SUBJECT: Forwards copies of responses to NRC 780918 ltr requesting
 addl info re Instrumentation & Controls Sys. Responses to
 be formally inserted in FSAR as an Amend in Feb 1979.
(see reports)

G02-79-04
January 5, 1979

Subject: WPPSS NUCLEAR PROJECT NO. 2
RESPONSES TO INSTRUMENTATION AND CONTROL
BRANCH, REACTOR SYSTEMS BRANCH, AND
HYDROLOGY-METEOROLOGY BRANCH QUESTIONS

SOLENOID #1
AC CONSTRUCTION

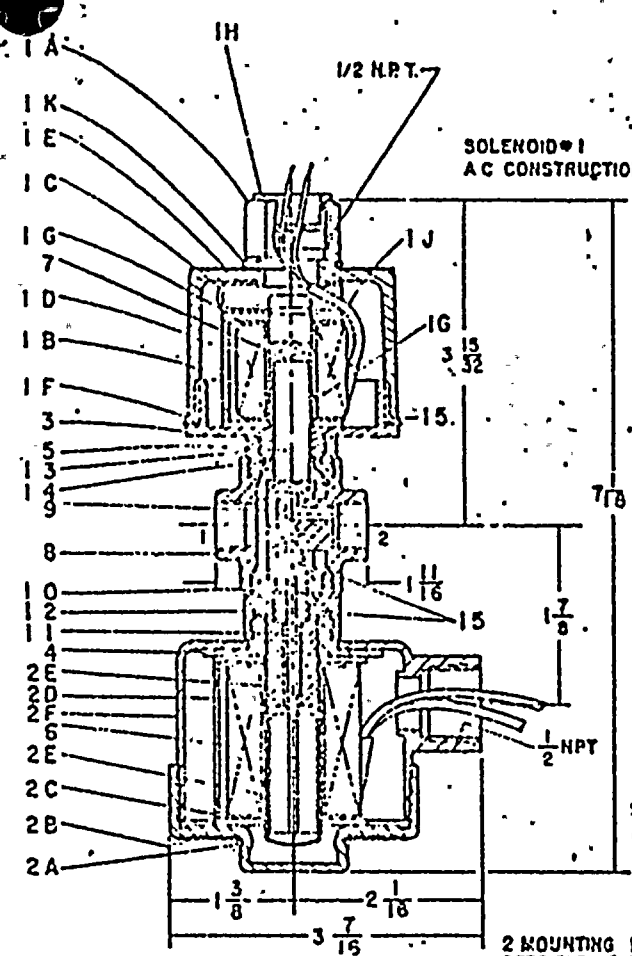
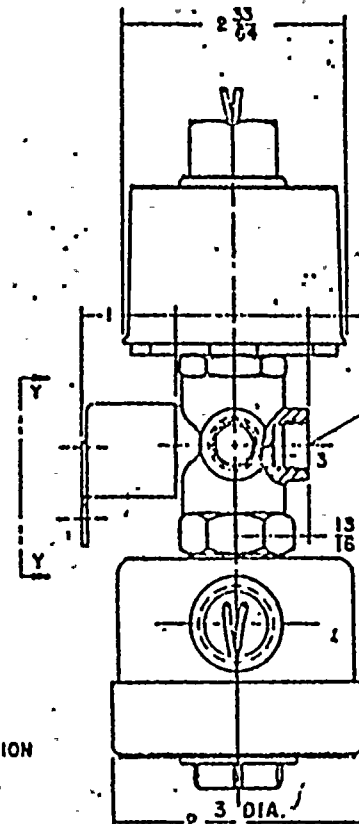
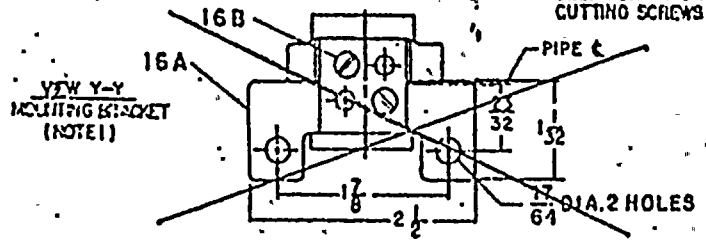
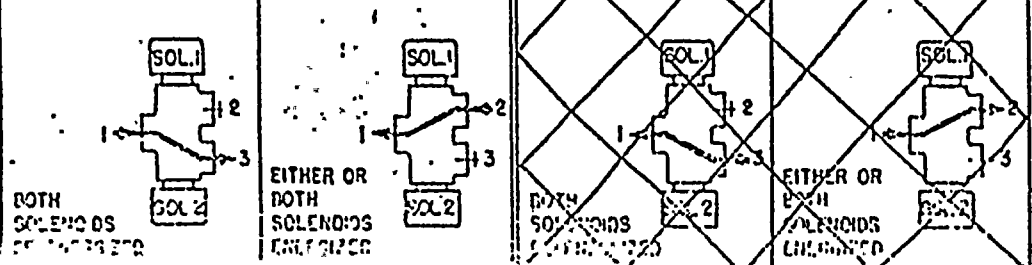
Your response to Item 031.001(h) presents a new design for the logic of the main steam line isolation valves which is different from that reviewed and accepted for licensing on similar boiling water reactors. Provide the manufacturing drawings for ASCO Valve No. 832320. Additionally, provide the results of the engineering analysis and the test results which demonstrate the ASCO Valve No. 832320: (1) is qualified for the environment in the drywell following a loss of coolant accident; (2) is seismically qualified; (3) meets the physical separation and the required electrical independence in accordance with the staff positions contained Regulatory Guide 1.75; (4) satisfies the single failure criterion (previous designs accepted for licensing have used two separate valves in a one-out-of-two logic for a reactor trip). Note that Table 1.6-1 of the FSAR states that the GE Topical Report, APED-5750, is applicable to the WNP-2 facility and that Table 7.1-1 indicates the main steam line isolation valves are designed and supplied by GE. Accordingly, provide justification for the change to the design which was previously reviewed and approved by the staff in our evaluation of the GE Topical Report, APED-5750.

- (1) ASCO Valve #832320 is a fail safe valve and closes by current deenergizing. This valve's application does not require it to function following a LOCA. The valve has been qualified for normal ambient conditions (VPF #3680-1) as follows:

- (3) The protection system criteria of IEEE 279-1971 are met with this design; the requirements of Reg. Guide 1.75 were not committed for this plant.
- (4) The ASCO valves in question are not used in generating a reactor trip. The ASCO valves are used in a two out of two logic for each MSIV. That is, in order for each MSIV to be isolated both ASCO solenoids must deenergize. The ASCO valves themselves are not single failure proof. Single failure criterion is preserved since each main steam line contains two valves in series. If a single failure occurs in one valve scheme the second will provide isolation.

There is no deviation from the commitments made in APED-5750.
